CONSTRUCTION DOCUMENTS REVIEW

August 20, 2007

RE: QUIZNOS SUB
East Judge Perez, Store #7452
2022 E. Judge Perez
Chalmette, LA 70043

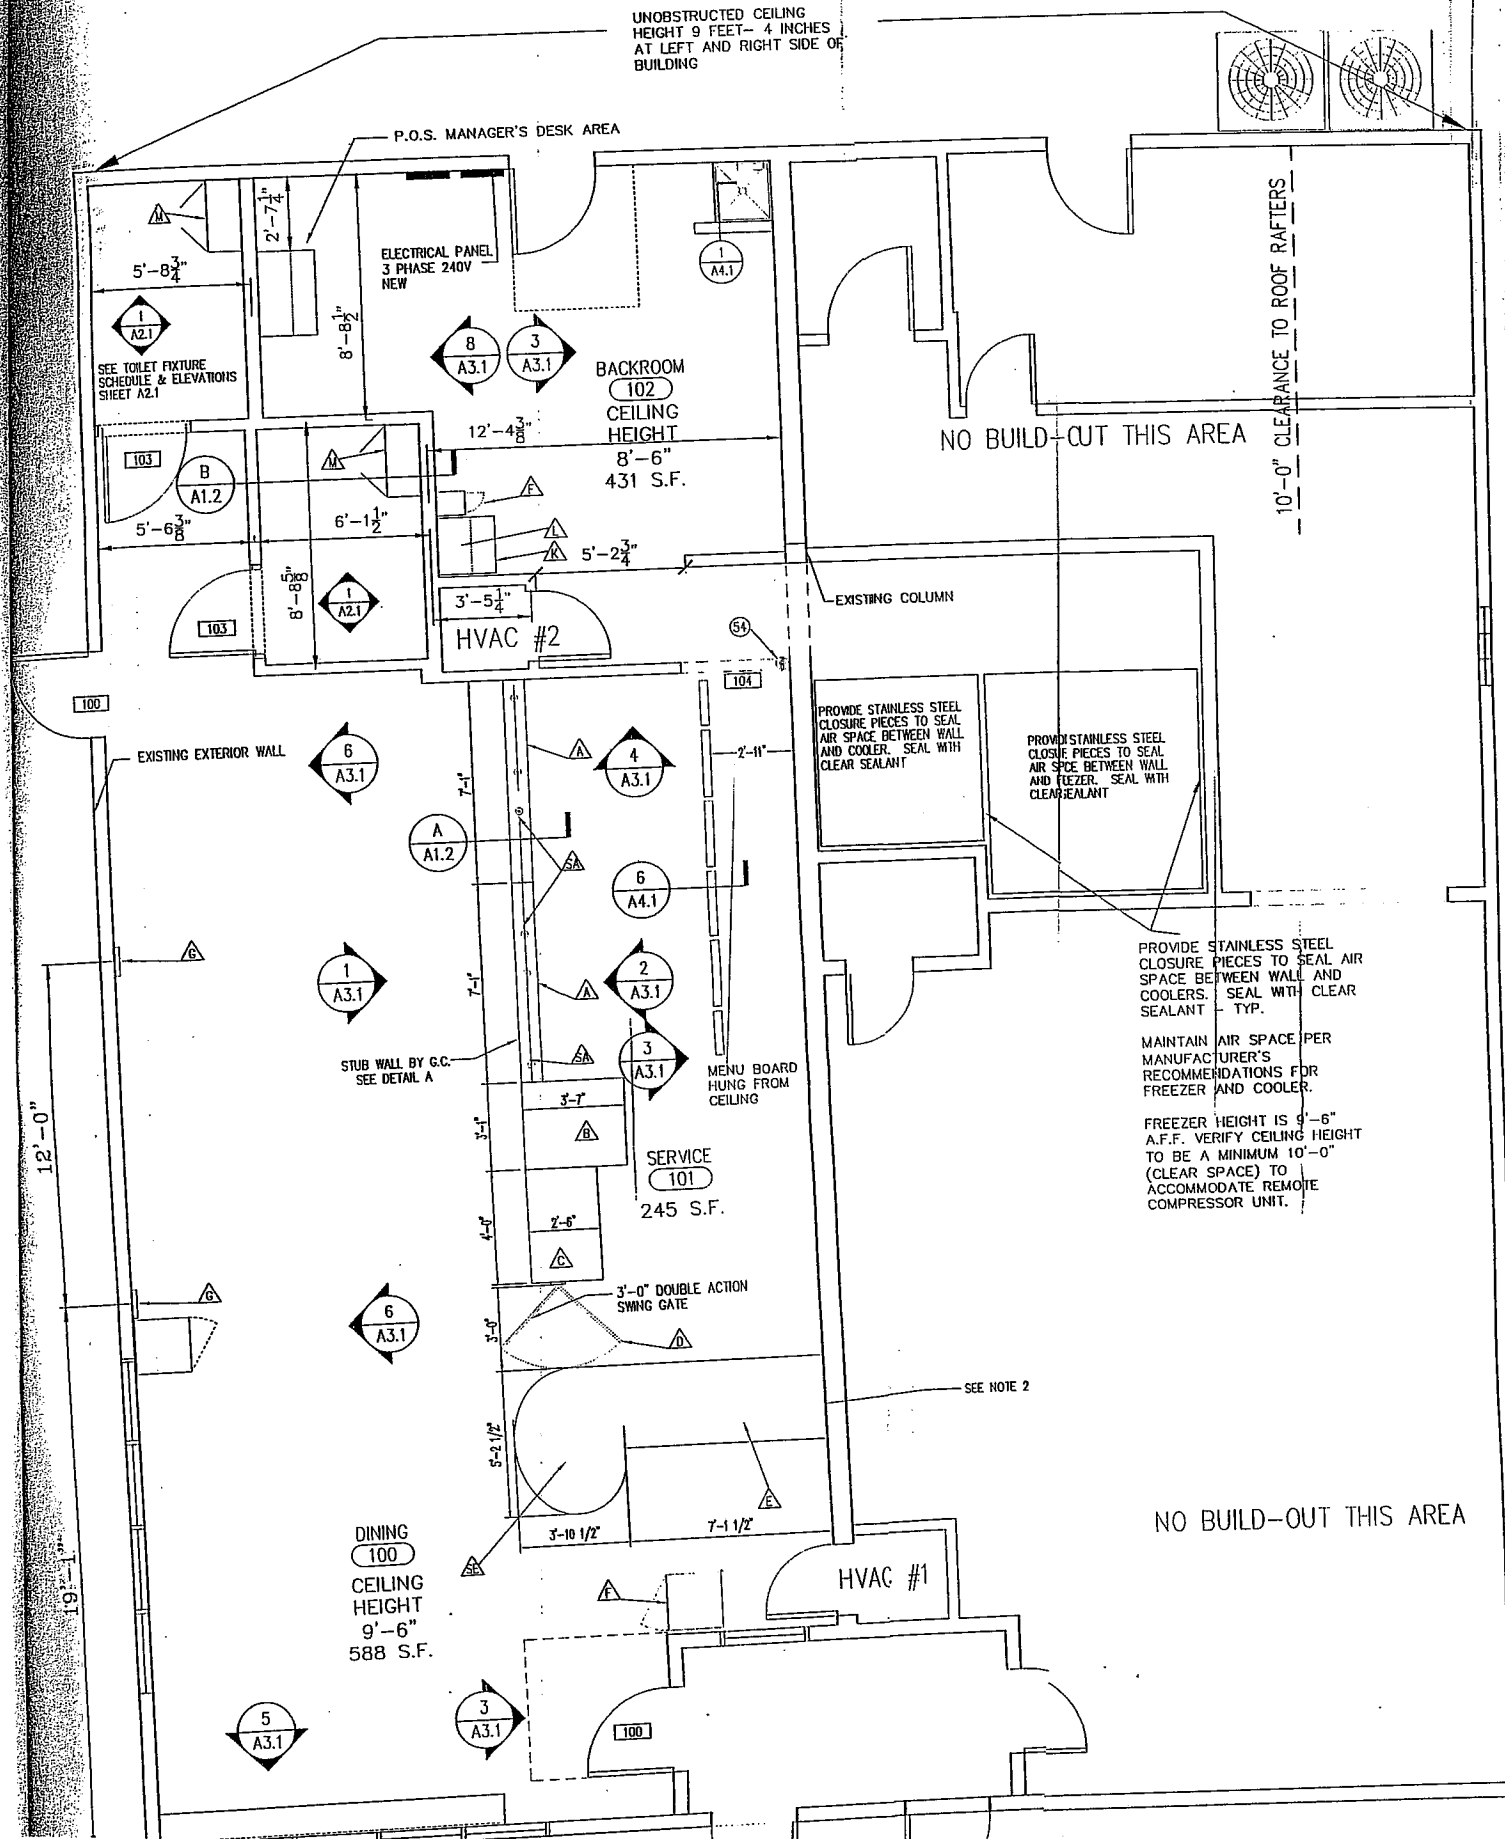
- f. A 6x6x7'6 cooler, remote compressor, will be ordered. Verify.
 - g. A 240V toaster will be ordered. Verify.
 - h. **Effective immediately- Place the toaster oven 6" to 8" away from the FRP to prevent the FRP from melting due to high temperatures from the toaster oven.**

- i. **Verify clearance of service line due to toaster moving.**

electrical outlet

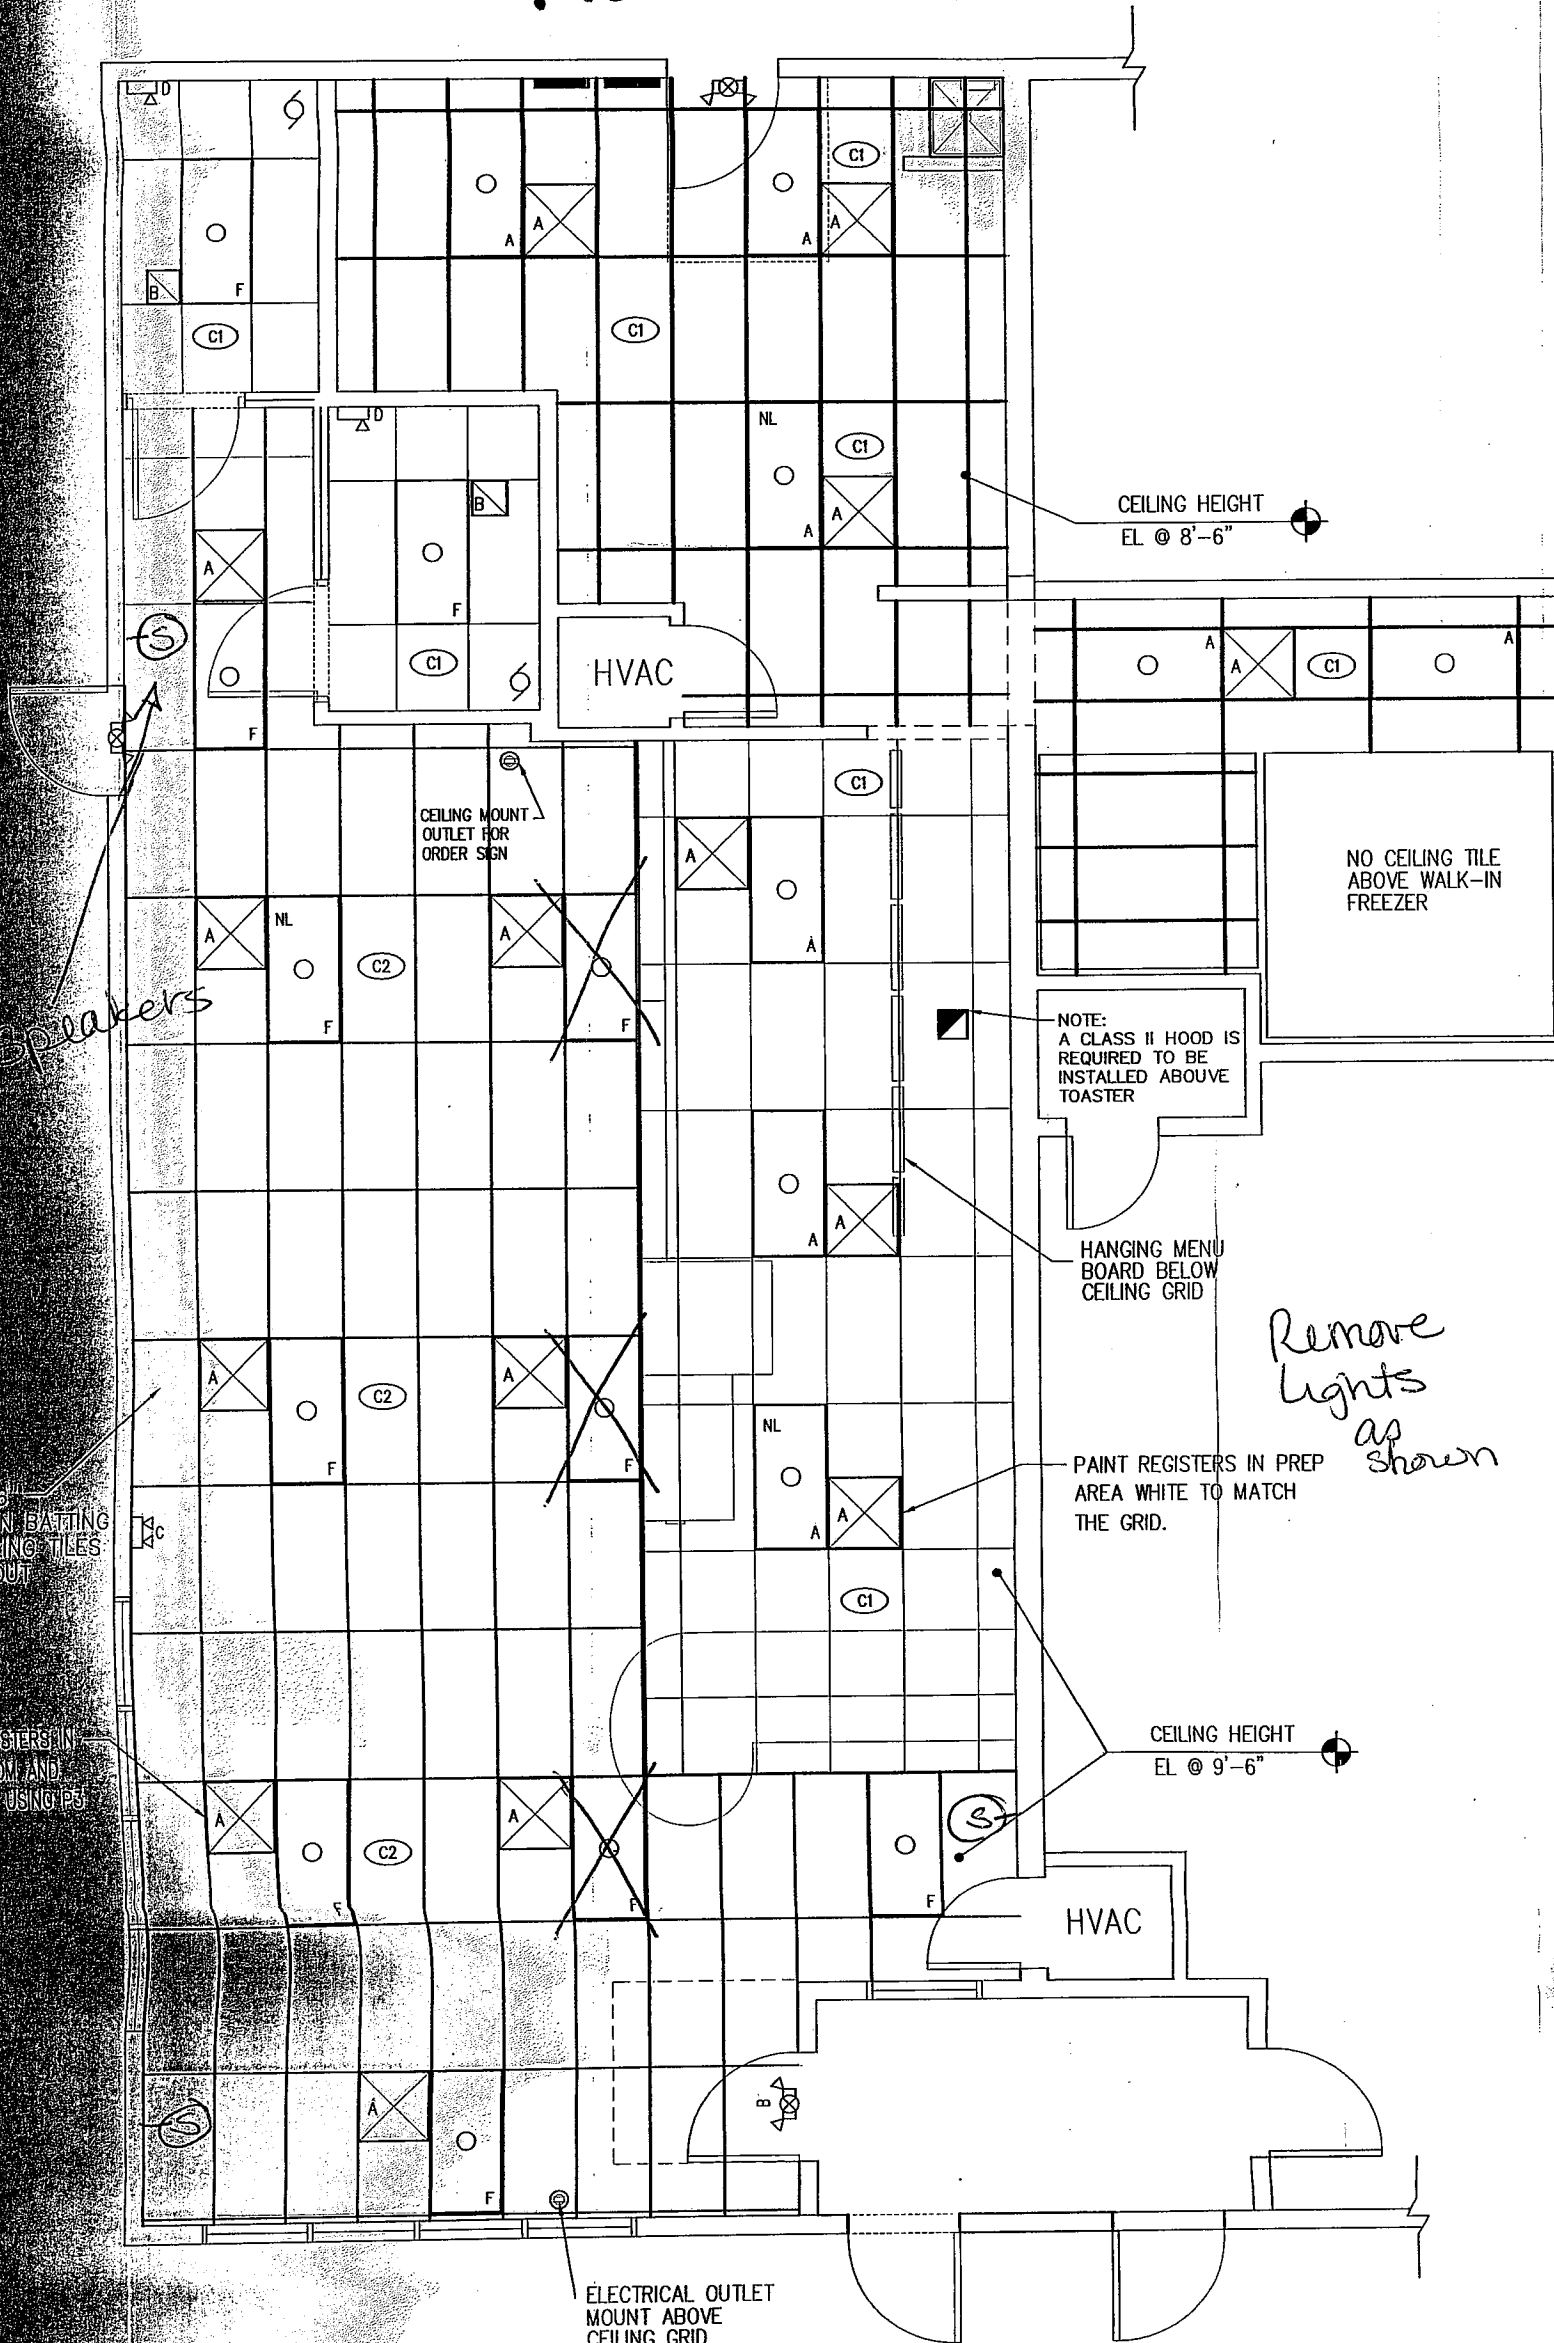
- d. A standard Q-Vent will be ordered per the QVent worksheet.
 - e. An 8x8x9'6 freezer, remote compressor, will be ordered per the Kolpak worksheet. Verify.

FREEZER HEIGHT IS 9'-6"
A.F.F. VERIFY CEILING HEIGHT
TO BE A MINIMUM 10'-0"
(CLEAR SPACE) TO
ACCOMMODATE REMOTE
COMPRESSOR UNIT.
